## **Revised proposal for a new [0x] series of amendments to UN Regulation No. 48**

For a more efficient discussion during the 83<sup>rd</sup> session of GRE the experts from the International Organization of Motor Vehicle Manufacturers merged documents GRE/2020/08-Rev.1 (SLR) and GRE/2020/23 into one document.

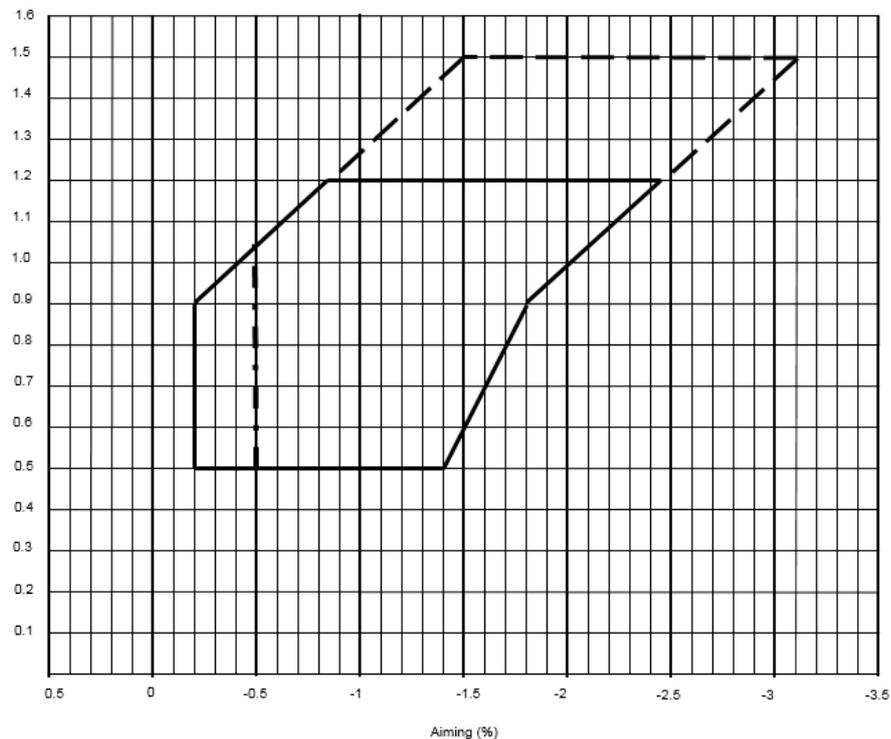
6.2.6.1.2. **Vertical inclination limits of the cut-off**

Depending on the mounting height in meters (h) of the lower edge of the apparent surface in the direction of the reference axis of the **passing beam (dipped-beam) headlamp**, measured on the unladen vehicles, the vertical inclination of the cut-off of the **passing beam (dipped-beam)**, **starting from the initial downward inclination value set by the vehicle manufacturer as prescribed in paragraph 6.2.6.1.1.**, shall under all the static conditions of Annex 5, remain between the following limits and the initial aiming shall have the following values, **under all the static loading conditions of Annex 5:**

<i>Mounting height h [m]</i>	<i>Upper inclination limit [per cent]</i>	<i>Lower inclination limit [per cent]</i>
$0.5 \leq h \leq 0.9$	-0.20	-1.40 to -1.80*
$0.9 < h \leq 1.2$	-0.20 to -0.85*	-1.80 to -2.45*
$1.2 < h \leq 1.5^{**}$	-0.85 to -1.50*	-2.45 to -3.10*

The above limits and the initial aiming values are summarized in the diagram below.

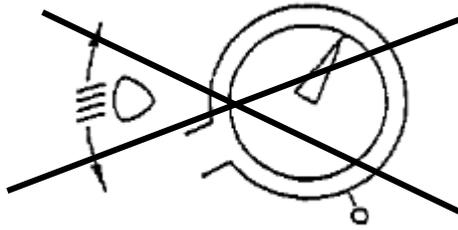
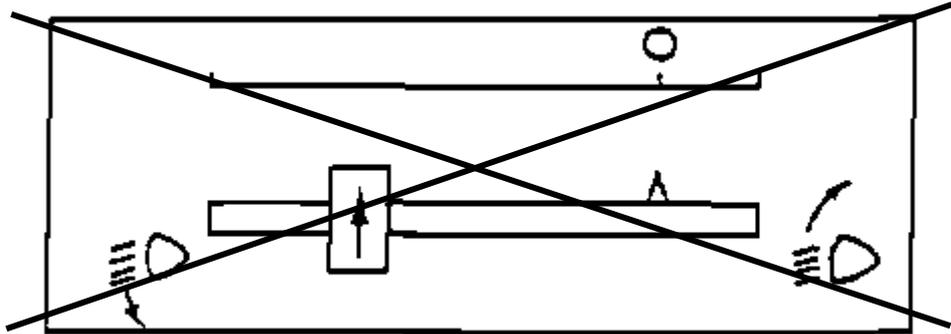
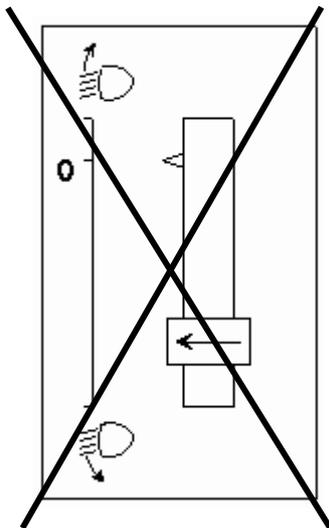
~~Symbols employing five lines instead of four may also be used~~

8. 'Downward' should be deleted. In the old text it referring to the direction of the control device. For trucks we are adjusting the dipped beam both upwards and downwards due to different loading characteristics of different vehicle configurations.
  9. In order for the requirements to be technology neutral, the prescription of control methods (downwards, rotary, push-pull) have been deleted.
  10. Requirement 1.3 referring to the owner's handbook has been moved into the main regulatory text (see paragraph 6.2.6.2.2.5.) and therefore can be deleted.
  11. Requirement 1.4. specifying the symbols, which can be used, has been deleted as these are already prescribed in UN Regulation No. 121.
  12. Examples of controls 1, 2 and 3 have been deleted as the illustrations are considered outdated.
-

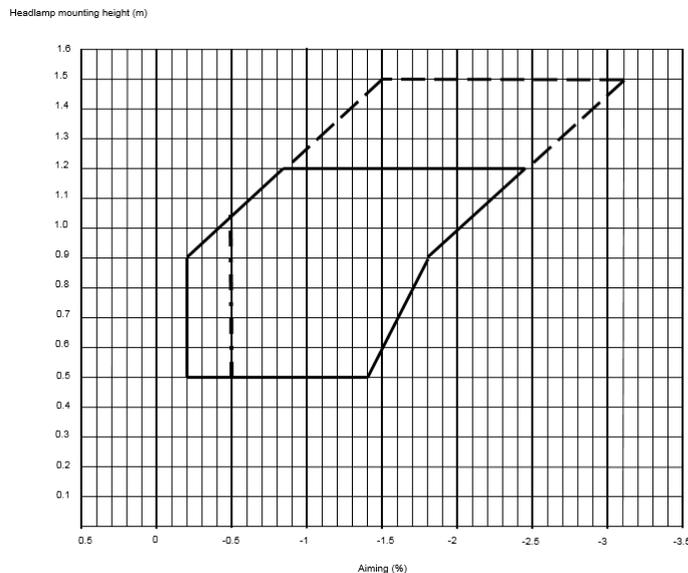
14. Paragraph 6.2.6.1.2. describes the new requirements for the vertical inclination limits of the cut-off, the provisions of which have been reorganised to improve readability. The vertical inclination values according to the installation height are presented in a table. A new

diagram has been inserted providing an illustration of the requirements (aiming in per cent on the horizontal axis and headlamp mounting height in meters on the vertical axis).

15. Explanations of the lines in the diagram are given below.

16. The vertical line on the left was initially defined at 0 per cent and derived from the GTB study based on the ‘Klettwitz study’ (informal document GRE-71-32). However, some Contracting Parties were reluctant to have the horizontal cut-off with no downward inclination. At its seventy-eighth session, GRE experts decided to keep the previous vertical limit of - 0.2 per cent.

17. The inclined line on the left (starting from 0.9 m\* in height), results from a mathematical calculation based on the position of the oncoming driver’s eyes (at 0.94 m high) for headlamps up to a height of 1.2 m, measured at a distance of 25 m and with an initial aim of 1 per cent down. Using this calculation, it is possible to increase the inclination proportionally to the installation height and still guarantee that glare remains under control; the cut-off line will always stay under 0.94 m at 25 m distance (informal document VGL-10-03, sheet 13).

18. In addition, the line on the left side of the diagram was extended from a height of 1.2 m to 1.5 m in spite of the fact that, during the Klettwitz tests, no vehicles of categories M<sub>2</sub>/M<sub>3</sub>/N<sub>2</sub>/N<sub>3</sub> were tested. This is the reason the lines above a height of 1.2 m are shown as dotted lines.

19. To cover all possible cases of a same type of vehicle (aiming tolerances / chassis deviation / cut-off-line stability / tyre deviation / full or empty tank / levelling device), a range of 1.6 per cent was agreed (see a survey of the International Organization of Motor Vehicle Manufacturers (OICA), informal document VGL-10-10) and used to define the right hand limit and the point (-1.8 / 0.9), based on line defined in item 16.

20. Starting from 0.9 m high, the range of 1.6 per cent is applied to define the line on the right side of the diagram and up to 1.5m.

21. On the right side, under 0.9 m high, there was a compromise to reduce the range progressively to 1.4 per cent at a height of 0.5 m (ECE/TRANS/WP.29/GRE/81, para. 10 and Annex II).

22. The vertical dotted line at -0.5 per cent is already explained in item 10 to address the PTI concerns.
